**Re: Del Norte Baptist Church  
5800 Montgomery Blvd. NE  
Grading & Drainage Plan Engineer's Stamp Dated 8/1/17  
(G18D010)**

Based upon the information provided in the submittal received on 8/2/17 the above-referenced plan cannot be approved for Grading, SO-19, and Paving Permits.

Project No. 21635	Drawn By: WCU
Checked By: ds	Date: 05.26.2017
Sheet No. C101	Sheet Of: 01

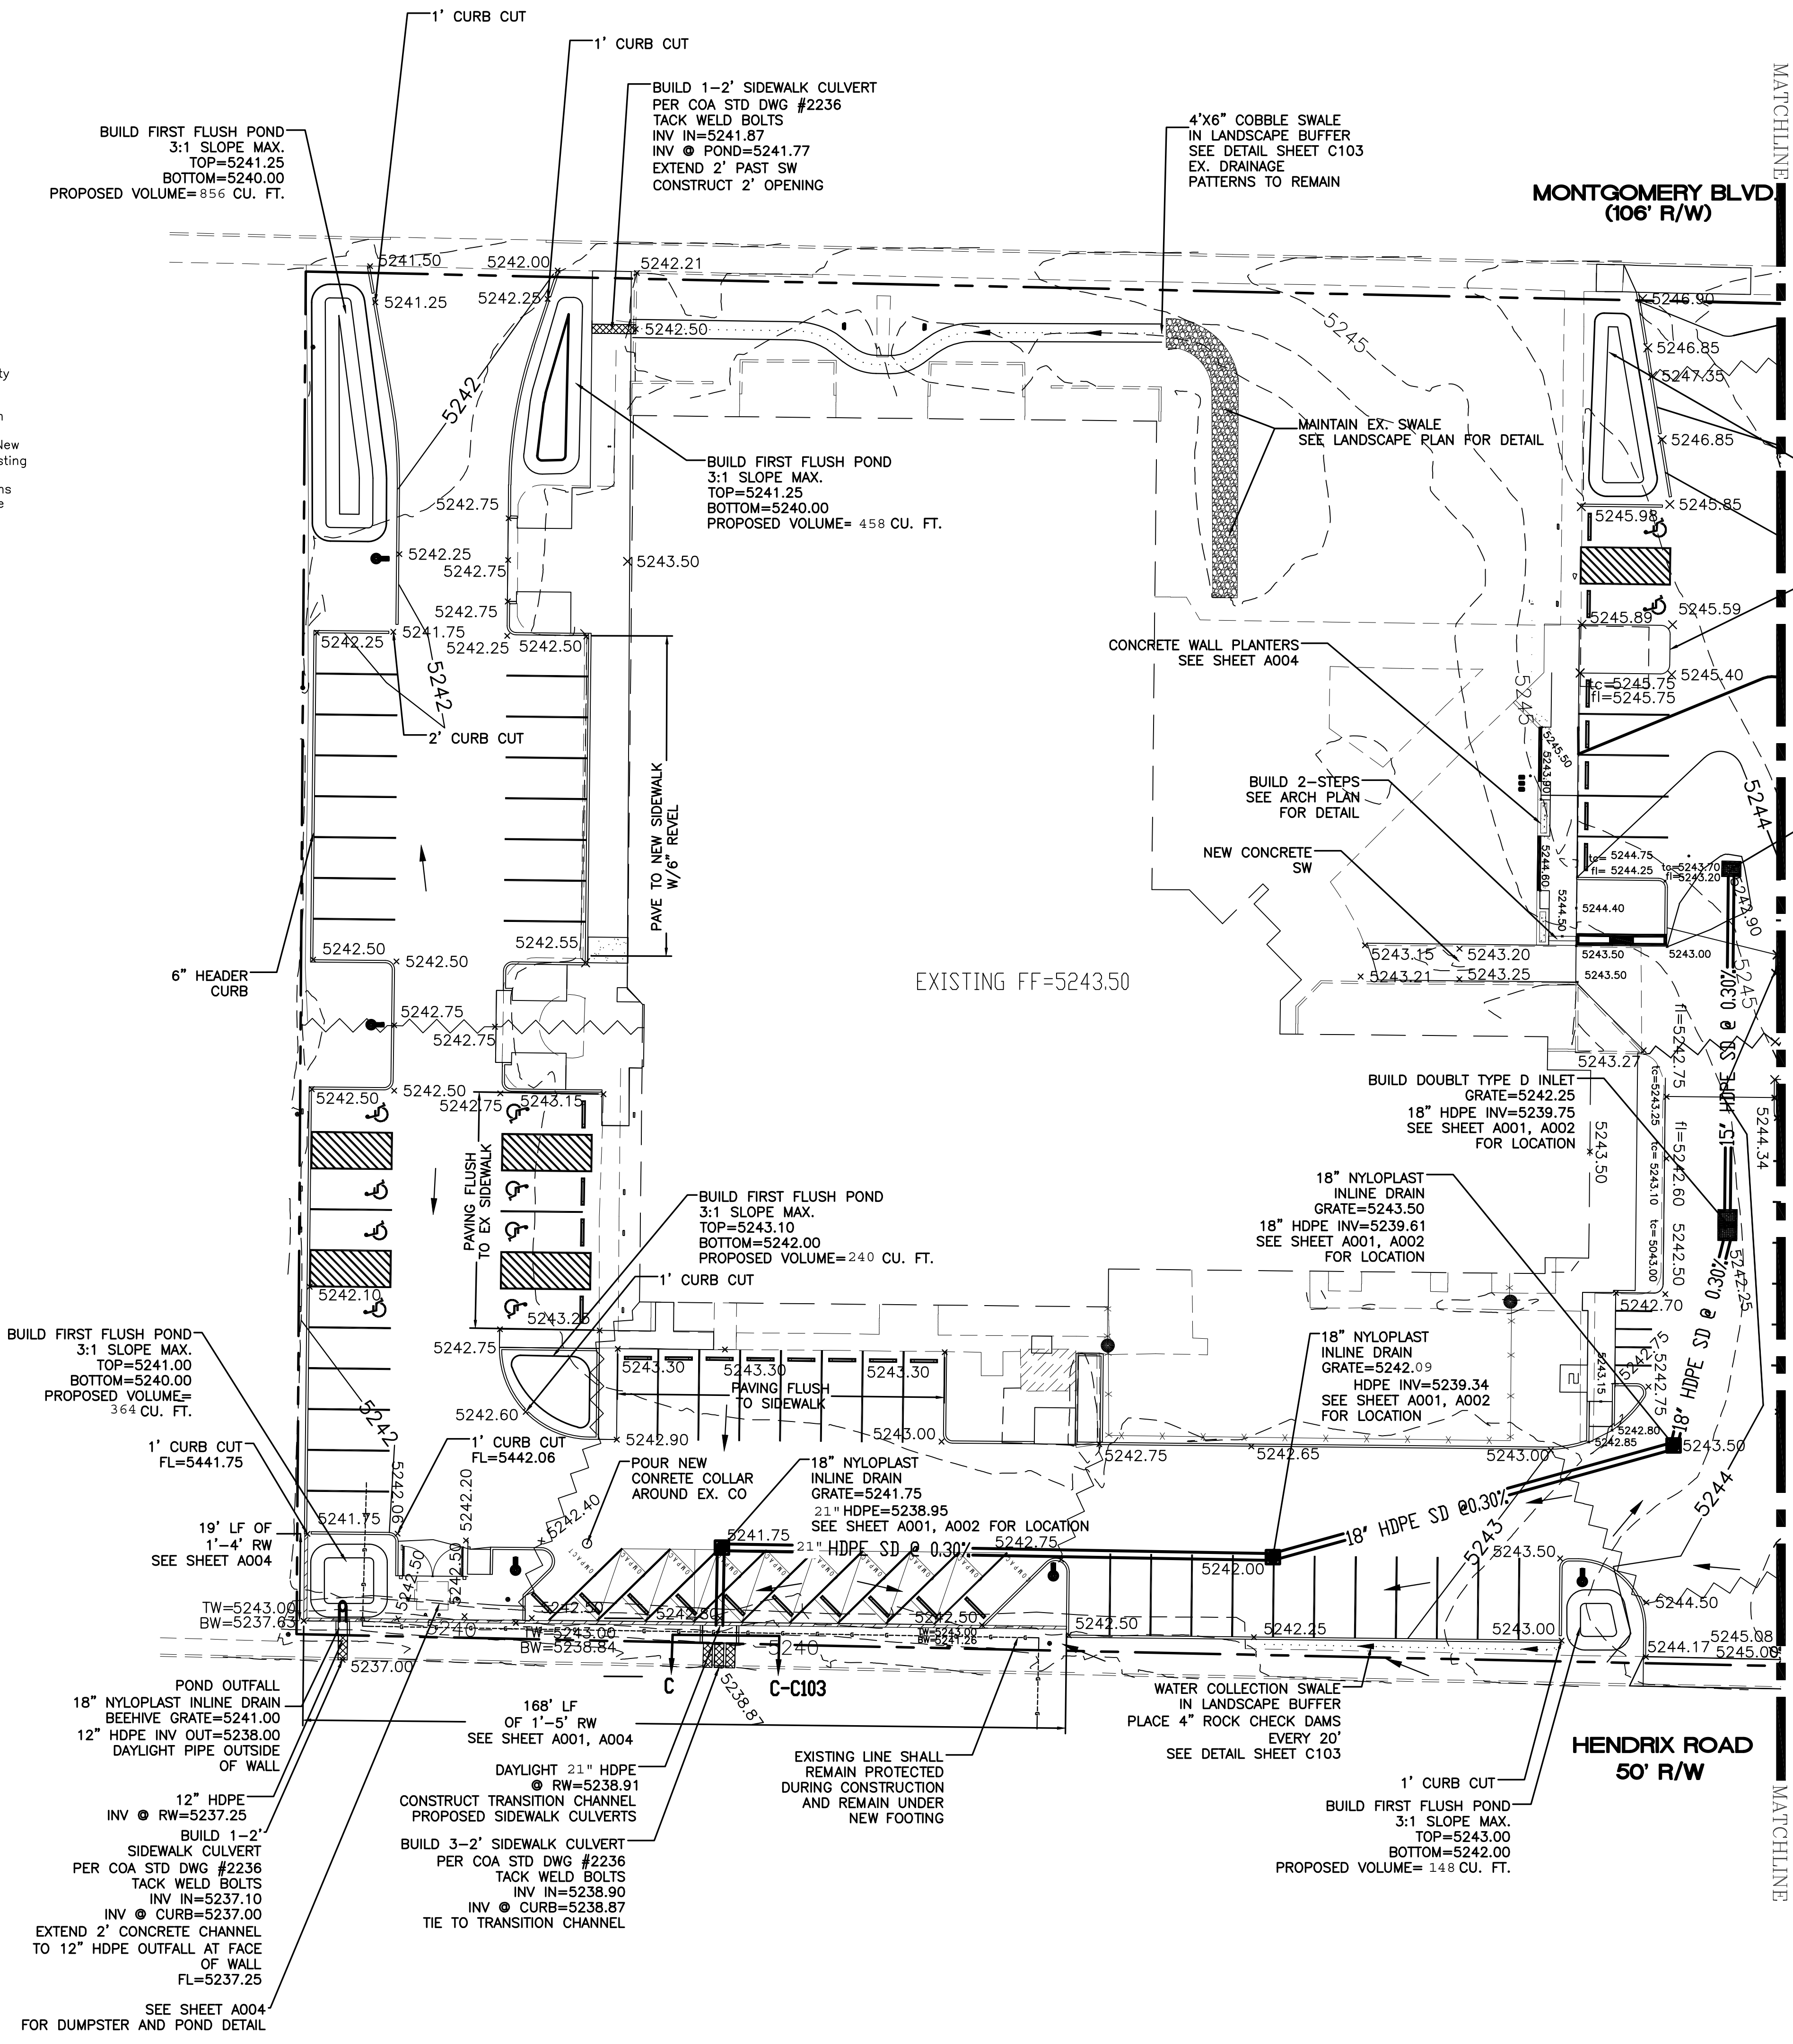
- Correct the Legal description "Lots B, C, and C2B"
- Add the SO-19 notes so that this plan can be used to obtain an SO-19 Permit for the sidewalk culverts, driveways in the public right of ways.

- Clearly indicate limits of removal and disposal on separate sheet.
- Clearly indicate new paving and sidewalks with hatch patterns and curb and gutter types to be constructed this project. Resolve discrepancy between legend and plan view.

- Topo survey needs work. Show existing drive pads, retaining walls, and slope paving more clearly on grading plan.
- Show existing elevation of adjacent properties at least 10' beyond the limits of this site, both contours and elevations.

- Add existing spot elevations all around perimeter next to each proposed elevations. Spots should be spaced about every 50'.
- Add Driveway and HC ramp detail per City Standard Specifications. Provide 0.87' water block height along Montgomery Blvd.

- Sidewalk Easement may be necessary if sidewalk jogs into private property at driveway locations.
- Proposed driveways need to be shown in greater detail with ramps, and construction notes.
